**ENERGY STAR®**  
**MULTIFAMILY NEW CONSTRUCTION ~~HIGH RISE~~**  
**PROGRAM**

## **Simulation Guidelines**

***Version 1.0, ~~Revision 03~~***

***JanuaryMay 20159***

Figure 1: Wall construction utilizing shelf angle

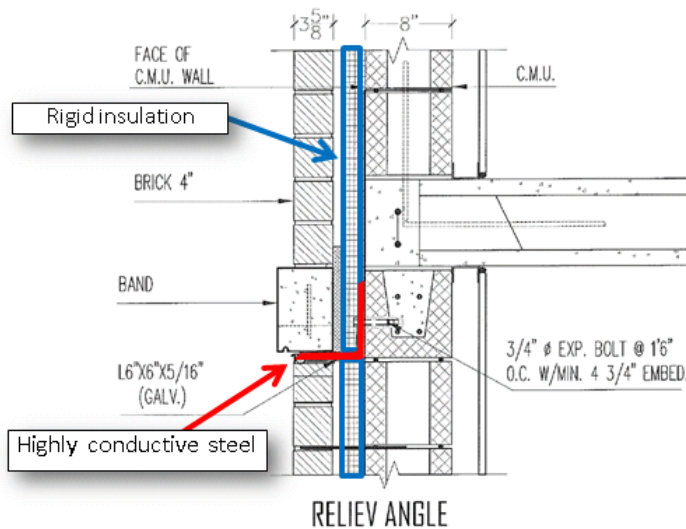
**3.4.8 Metal Shelf Angles Fasteners.** The *Proposed Design* model must account for thermal bridging through portions of the wall assembly where non-thermally broken shelf angles, metal clips, z-girts, brick ties, or other continuous metal fastened to the wall are used. Where those conditions exist (see Figure 1), the insulation cannot contribute to the assembly U-value-factor for those areas. An overall U-factorvalue shall be calculated based on an area weighted average of the thermal properties. For example, if the U-factorvalue of a wall assembly is U-0.064 for portions where there is rigid insulation and cavity insulation, the U-factorvalue for the areas thermally bypassed by the shelf angle could be reduced to U-0.097, if the rigid insulation is ignored. If the vertical component of the shelf angle comprises 5% of the vertical wall area, the overall U-factorvalue decreases to U-0.066 ( $U=0.064*0.95+0.097*0.05$ ).

**Commented [A7]:** Updated per footnote 24 of RF to clarify that thermally broken shelf angles are exempt from the de-rate

Example: The vertical portion of the wall thermally bypassed by the shelf angle (the red line in Figure 1) must be treated as having no rigid insulation when calculating the weighted average thermal properties of the wall in the *Proposed Design*.
